Project No. 620.041615

RE: Molong BESS

Review of Temporary Construction Laydown Area, Off-site Construction Traffic Volume Changes, and O&M Building Relocation

**PROPOSED TEMPORARY
LAYDOWN AREAS**

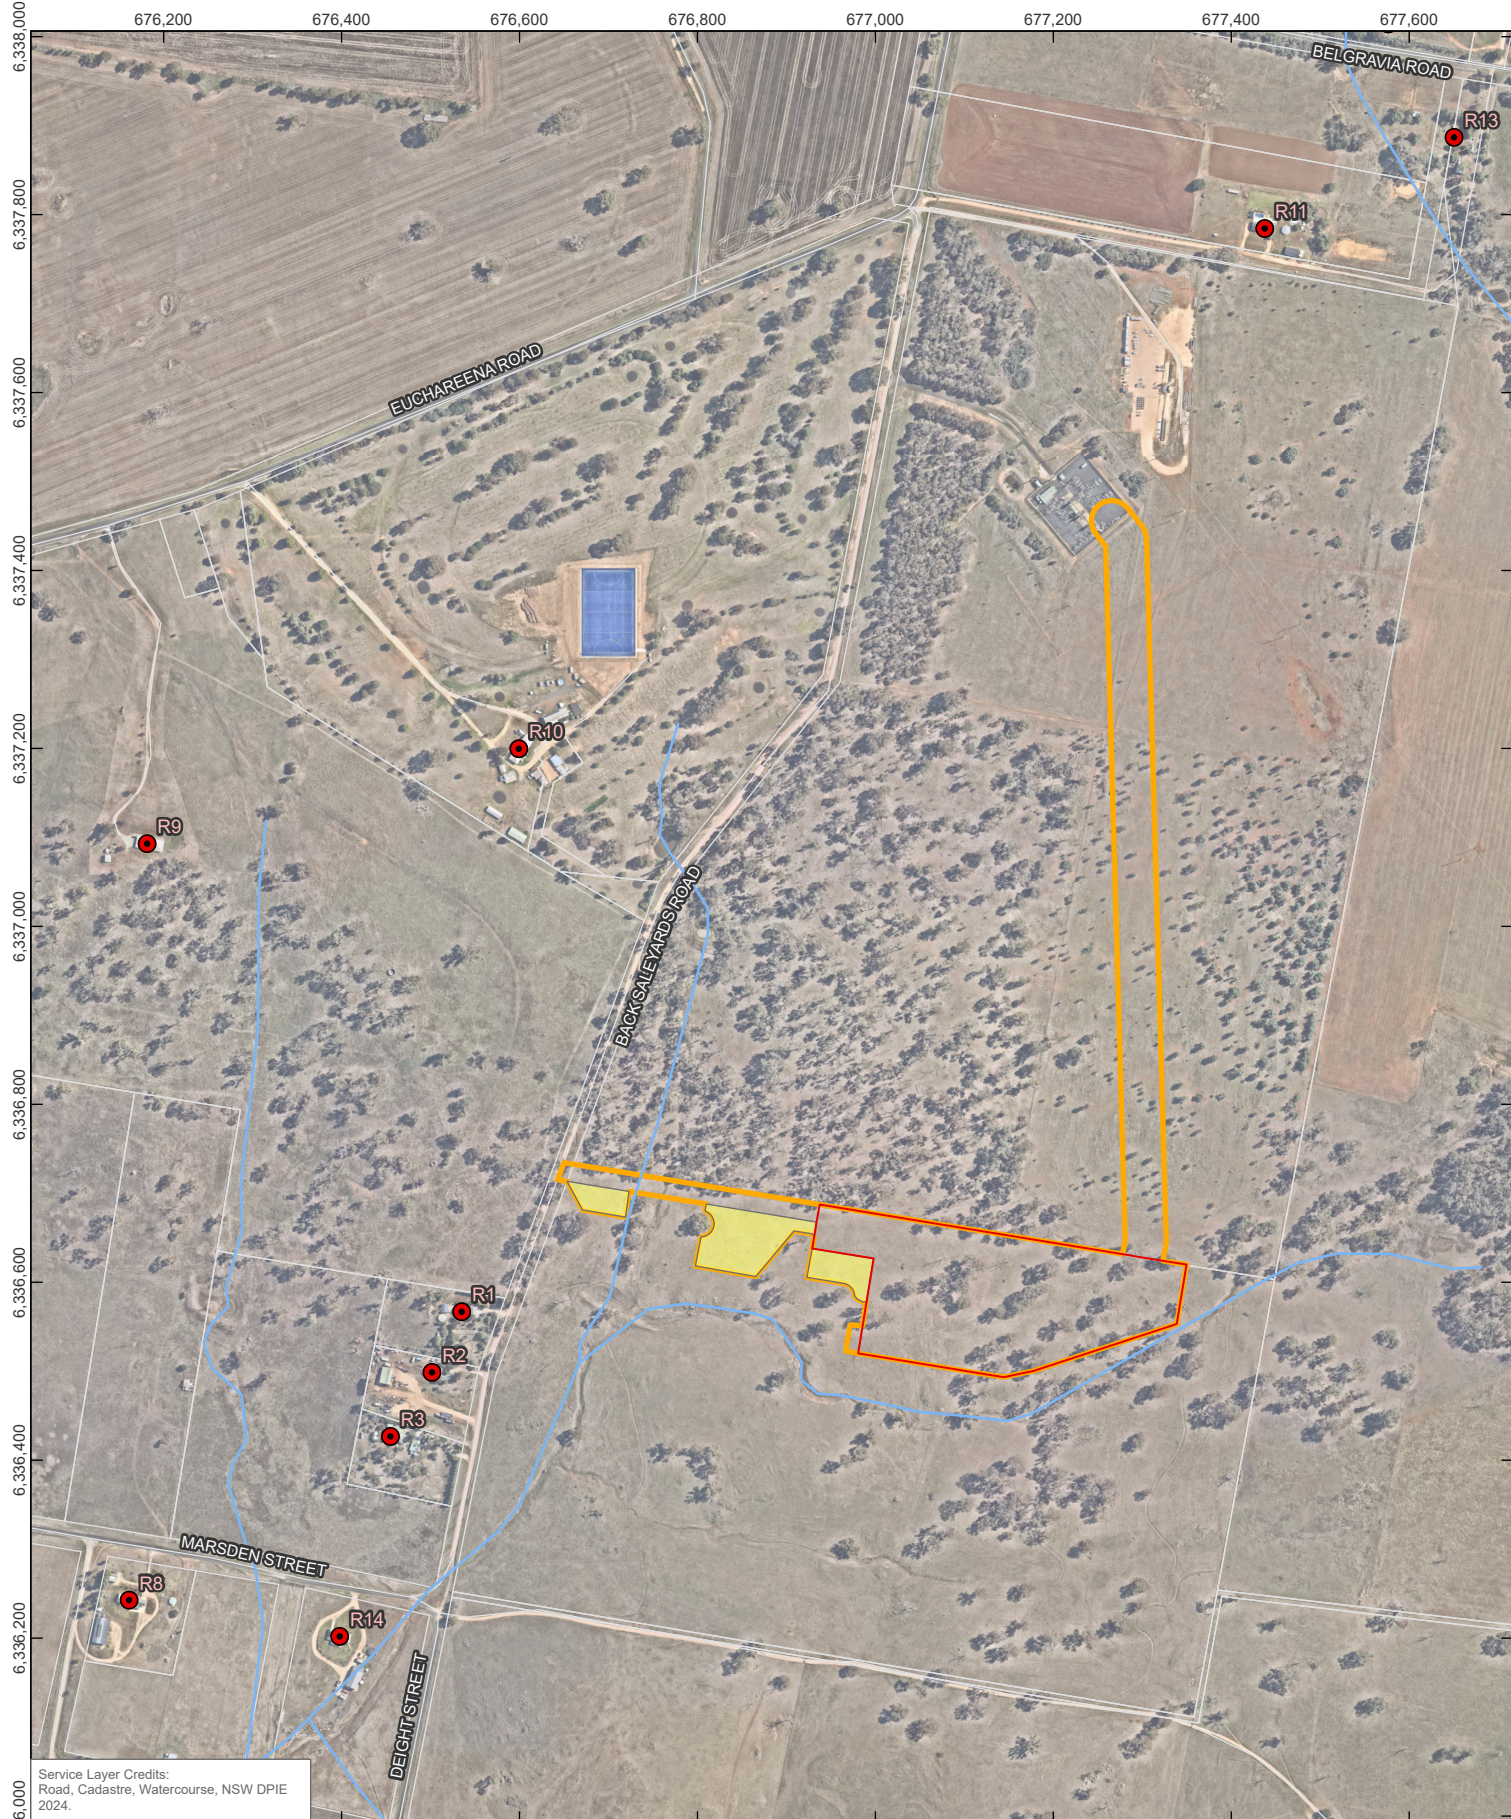
The updated laydown area comprises multiple temporary construction laydown areas located to the west of the Project development footprint. The revised laydown areas represent a change from the previously assumed configuration. The areas are temporary in nature and will be used for the staging and storage of construction materials and equipment during the Project construction phase. The activities within the laydown areas are anticipated to be limited to standard working hours only. **Figure 1** shows the location of the proposed temporary laydown areas.

The temporary laydown area is proposed to be used primarily for the storage and staging of construction materials and equipment. As a storage area, it generally does not represent a significant or continuous source of construction noise. Activities associated with the laydown area, such as vehicle movements and the occasional unloading or loading of materials, are inherently intermittent and of limited duration. The primary sources of noise within the laydown areas are anticipated to be trucks, and mobile plant such as excavators and dozers. No vibration intensive activities are anticipated during the use of the proposed laydown areas.

The proposed temporary laydown areas are located closer to the existing receivers to the west (R1, R2 and R3 as identified in the NVIA). The noise impacts of vehicles accessing the site are addressed in **Section 3.1**.

The construction of the site access road/driveway has also been previously assessed (scenario W.06 in the NVIA). The noise impacts from the worst-case laydown area location (western end of the site) are expected to be similar to this access driveway construction scenario during the worst-case laydown and material handling phase in this location (marginal exceedances expected to the existing receivers against the noise management levels). The noise impacts are expected to further decrease as the laydown areas further setback from Saleyards Road (towards the BESS footprint) are used.

On this basis, no material difference to the construction noise impacts previously identified in the NVIA is anticipated as a result of the change to the laydown area configuration.

FIGURE 2

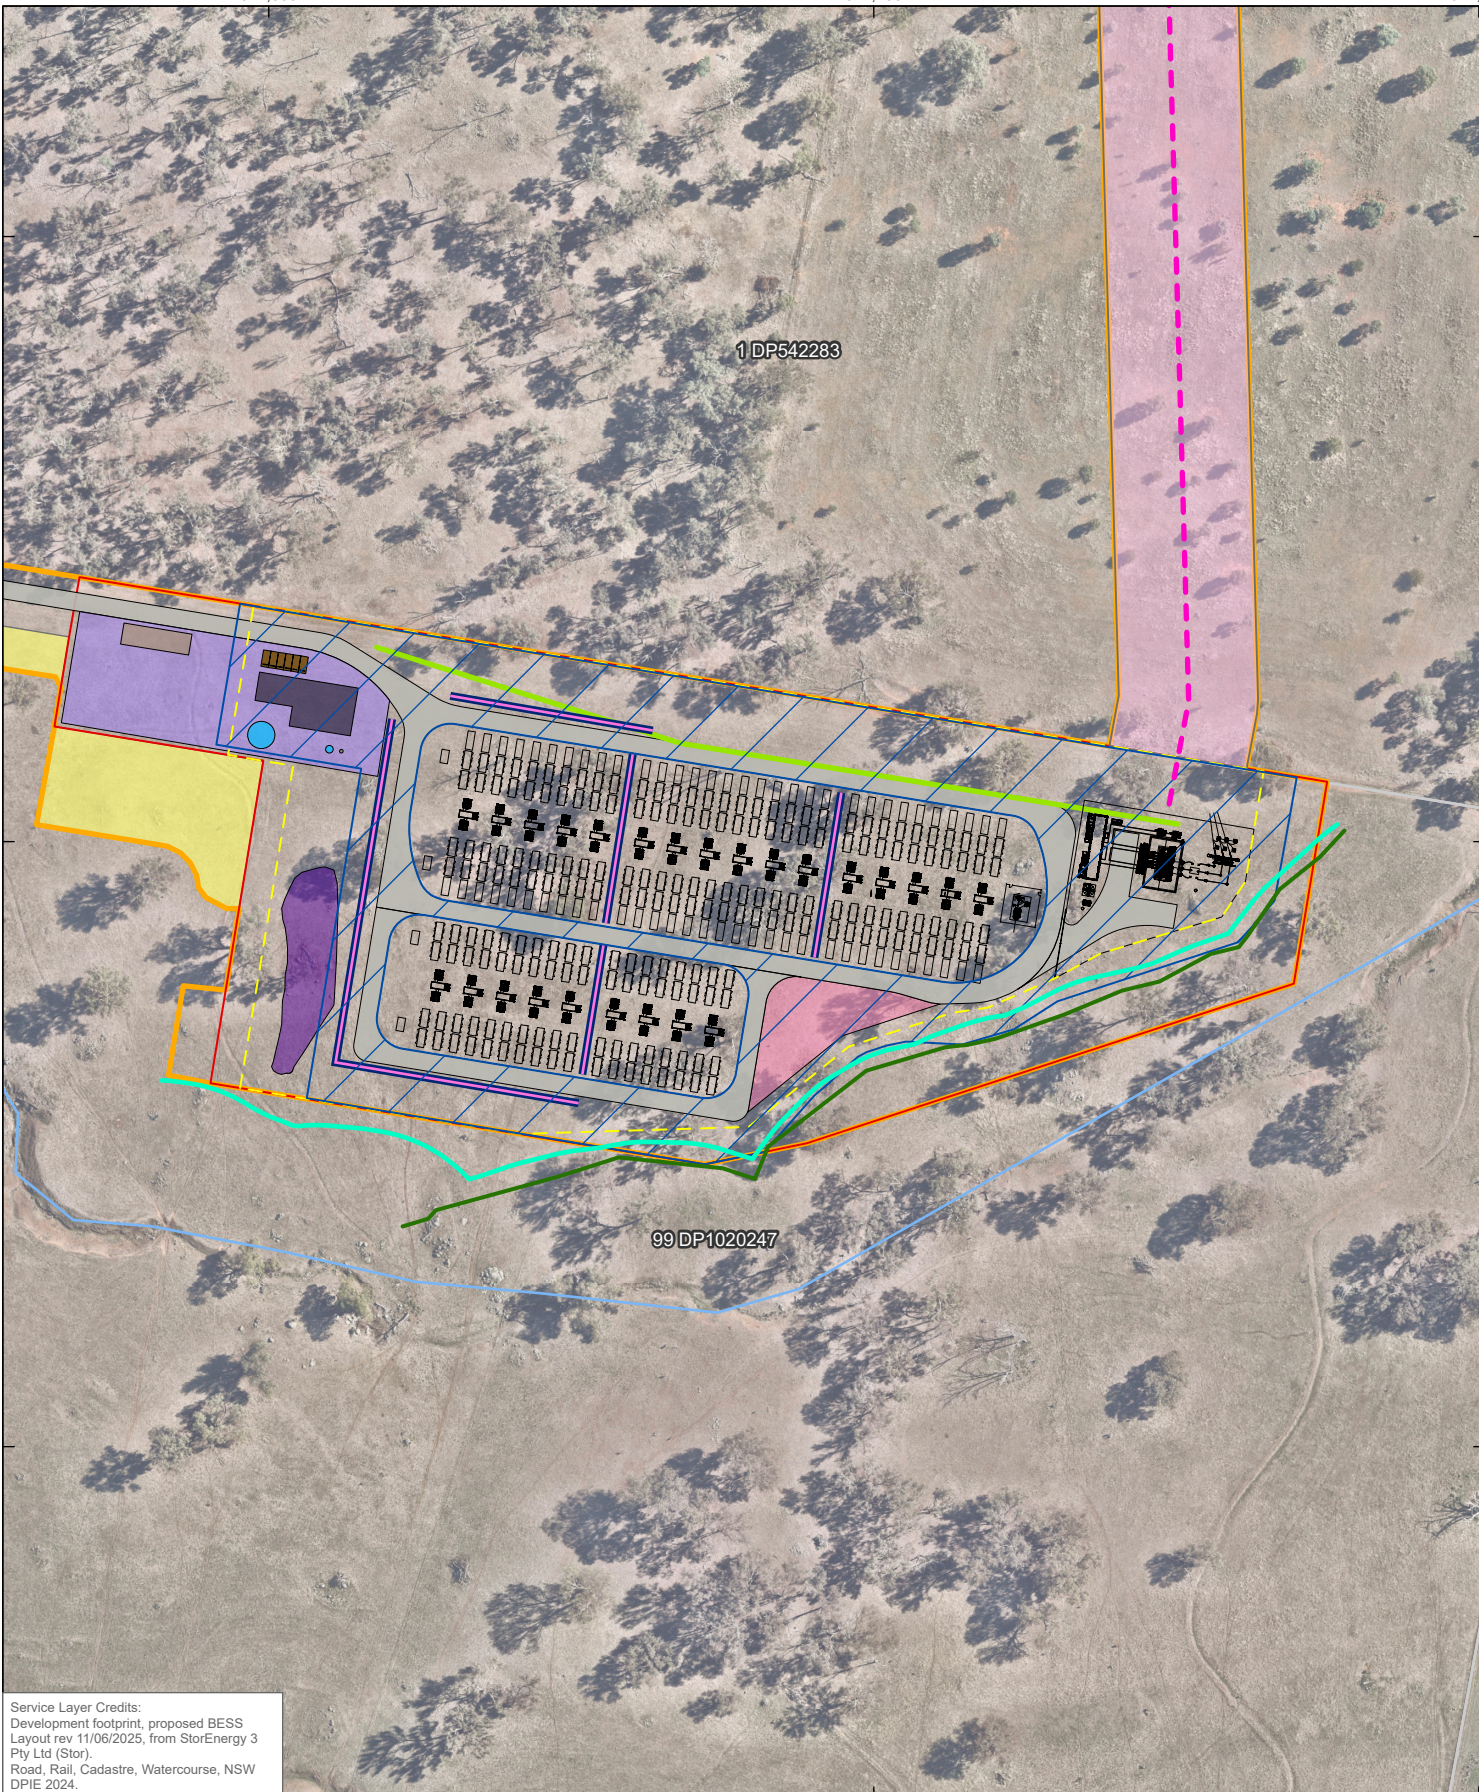
The O&M Building was previously located within the laydown area in the southeastern portion of the project site and has been relocated to the construction compound area at the western end of the site, as shown in **Figure 2**.

The relocation of the O&M Building will not result in any material change to overall project noise levels. The building will be primarily used for ancillary administration and storage purposes, and while it may include air conditioning units, any associated noise contribution is considered negligible given that overall project noise is dominated by the BESS infrastructure.
